BGA TECHNICAL COMMITTEE

TECHNICAL NEWSHEET (TNS) 11/12/94

PART 1 AIRWORTHINESS "AGGRO"

Abb. 1

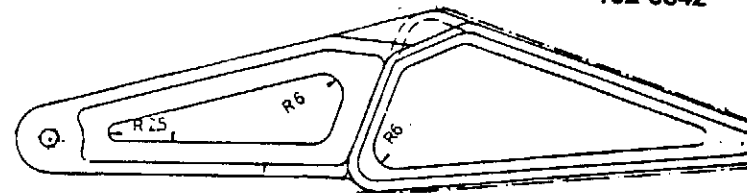
The elevator lever P/N 102-3542 (aluminum castings, Fig. 1) has to be checked for cracks using a proper test procedure (i.e. magnifying glass). If cracks are found, the elevator lever has to be exchanged according to the Installation Instructions No. 306-30/1, before the next flight.

Abb. 2

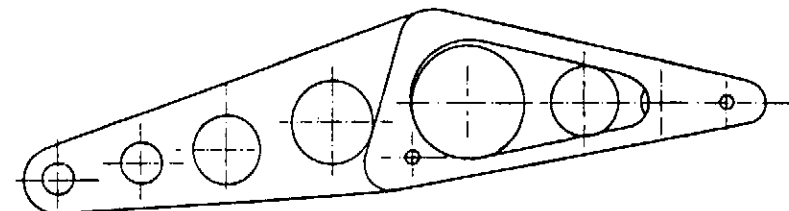
Procedure: The exchange of the elevator lever P/N 102-3542, made from aluminum castings (refer to Fig. 1, page 2) or made from aluminum sheet with openings/ lightening holes P/N 102-3541 (refer to Fig. 2, page 2), is already anticipated within the course of extension of the service life before reaching 3000 flight hours (refer to Service Bulletin TM 306-30). Now an inspection and an advanced exchange of the elevator lever by the elevator lever P/N 102-3543, made from aluminum sheet (refer to Fig. 3, page 3), is mandatory as a precautionary measure.

Fig. 3

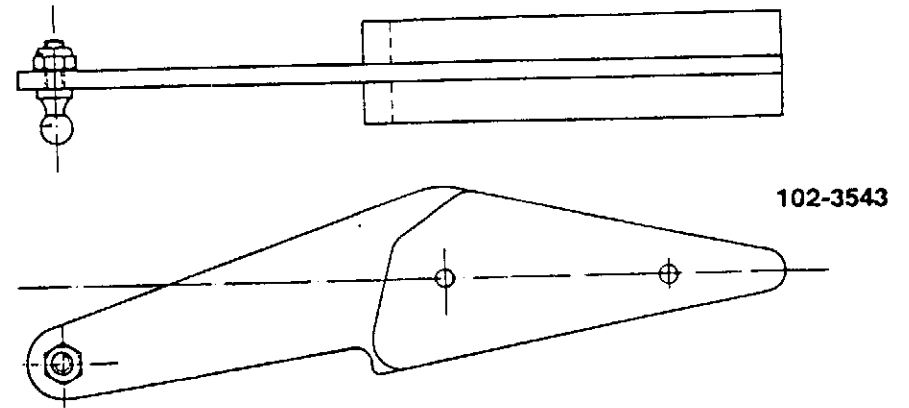
If no cracks have been found during the inspection according to Action 1, the castings elevator lever and all other lever models have to be exchanged by the elevator lever P/N 102-3543, made from aluminum sheet (refer to Fig. 3, page 3) according to the Installation Instructions No. 306-30/1 not later than 31.12.1994.

CRACKS in DISCUS BT ENGINE FRAME

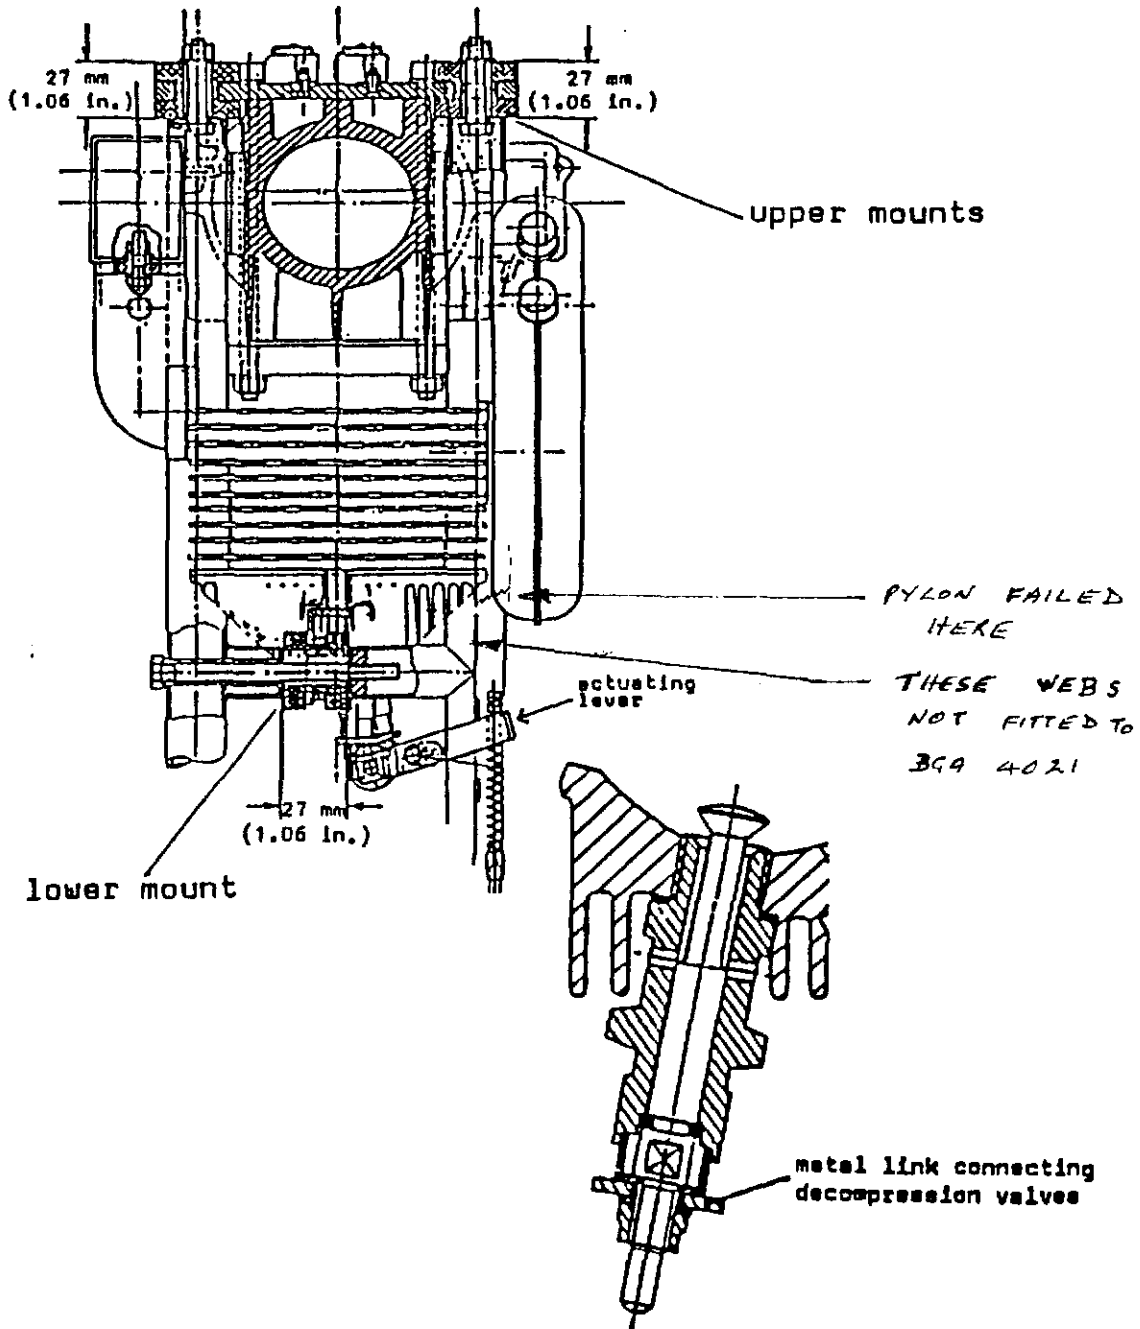
- 1.2. DG500 Elan Trainer LBA AD 94-295 and Tech Note 348/4T (herewith) restrict negative "G" manoeuvrers.
- 1.3. Discus bT - cracks in the engine mounting frame have been identified by Jim Tucker, Southdown G.C. (sketch herewith).

Scheme (Scale 2:1):

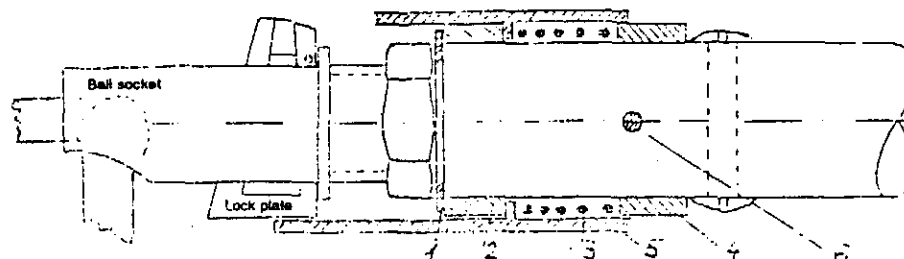
- remove L'Hottellier quick lock
- install parts in the item sequence 4, 3, 5, 2 onto the free end of the control rod
- item 1 has to be positioned during reinstalling of the L'Hottellier quick lock
- adjust exact length of the control rod and fix with lock nut
- push in bushing (item 4) 2 mm into the securing tube (item 5) and secure it in this position with the spiral pin (item 6) in the drilled hole (2.0 mm dia.). The spiral pin exceeds the bushing for 1 mm to each side.

The drilling must be in a vertical plane to the lock plate. The distance of the drilling center to the outer edge of the washer (item 1) is 19 mm. This distance guarantees that the securing tube is secured against turning (a turning of the securing tube would neutralize the automatic securing of the L'Hottellier lock plate).

- to prevent an unintentional moving of the bushing (item 2), it is recommended to fix the bushing using PATTEX or something similar prior to drilling.
- for a correct securing it is sufficient, if the securing tube (item 5) overlaps the lower part of the L'Hottellier lock plate for 3 mm
- if the overlapping is more than 3 mm, the front part of the securing tube can be grind accordingly

Subject: Inspection of the cylinder head valve seat

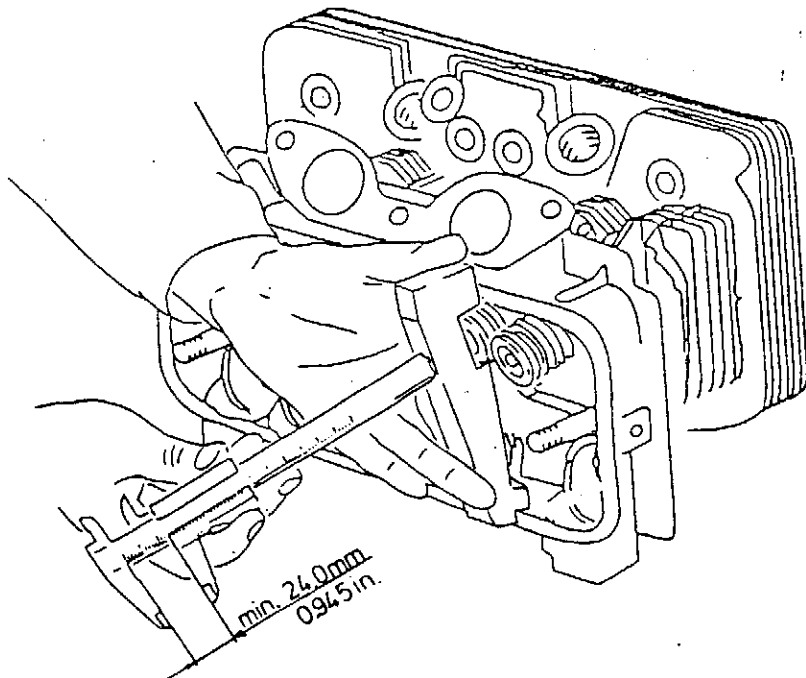
Procedure: After 500 to 600 hours operation time, it may occasionally occur, that the valves or the valves seat rings are pounded. To prevent excessive wear or damage, a regular inspection of the cylinder head valve seats is provided as a precautionary measure.

1. Remove cylinder head covers from both sides.
2. Measure valve play at all cylinders (nominal value: inlet and outlet valves 0,15 mm - 0,20 mm/ 0.006 - 0.008 in.) and note measured values.
3. Remove L/H and R/H rocker arm assemblies.
4. Position measurement device (P/N G2500-W1-630) above each valve as shown in the sketch below and measure distance to the end of the valve shaft using a depth gauge. This distance must be minimum 24,0 mm / 0.945 in. for inlet and outlet valves. If the minimum distance is reached, the affected cylinder heads have to be exchanged immediately.

E1. FLAP/AILERON CORROSION

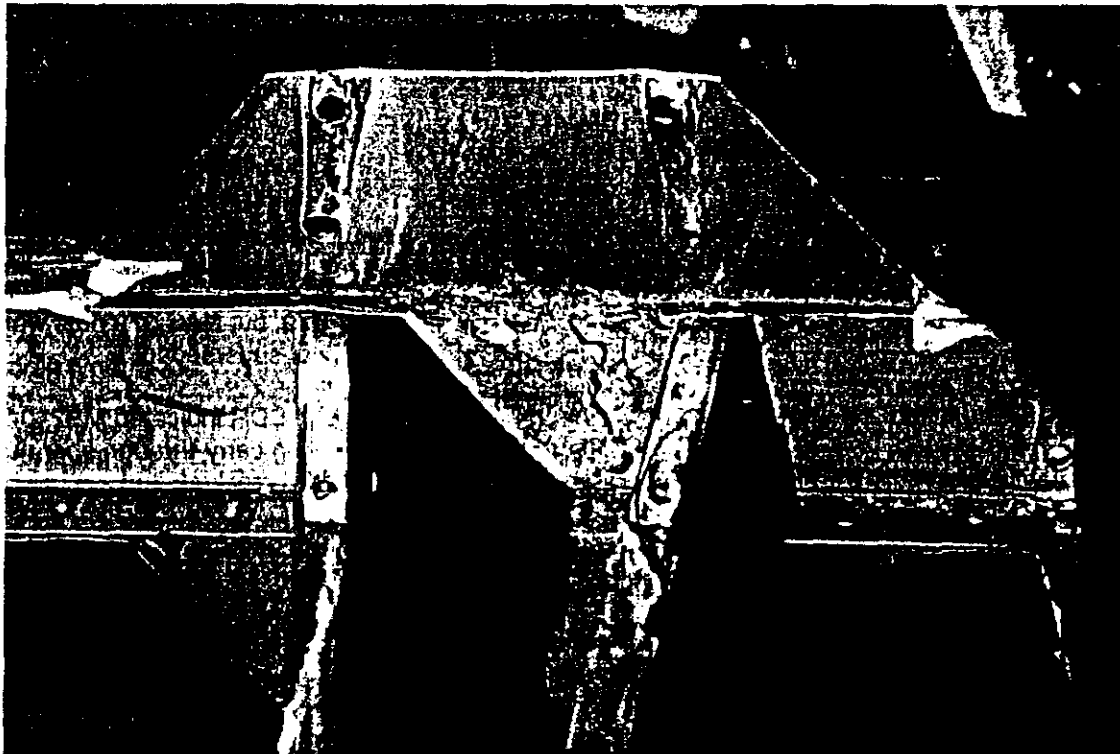
corrosion of the flap spar in the vicinity of the hinge attachment. The corrosion was so severe as to seriously weaken the flaps. The construction of the flap consists of a spar channel sandwiched between the hinge fitting on the forward face and the steel doubler on the rear face. The corrosion was be-

tween the aluminium spar and the steel hinge fitting.

The engineer reporting the hazard stated that the corrosion could only be detected by an internal inspection of the flap, with either the fabric removed or by making an access hole in the lower fabric covering. The photographs indicate the problem.
